**Re: PA22-044 – Olympic Vista PRD – Technical Review 2**  
4128 Sunnyside Blvd. APN 29050300102200

SUBJECT: PA 22-044 – Olympic Vista PRD, Technical Review #2

To: Tom Abbott, P.E.  
Amy Hess, Senior Planner  
From: Thomas J. Maloney, Fire Marshal  
Date: May 3, 2023  
Subject: PA22-044 Olympic Vista PRD 4128 Sunnyside Blvd Resubmittal

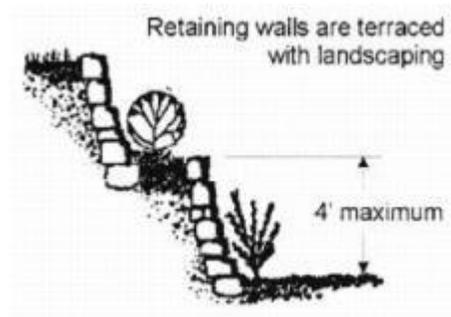
1. Pursuant to MMC 22D.050.030(4)(e), retaining walls taller than four feet and are visible from the street **or adjacent property** shall be terraced so that no individual segment is taller than four feet. This is anticipated to be a condition of preliminary approval. Compliance will be verified during civil construction plan review.

**Tall retaining walls must be terraced with landscaping as depicted below.**
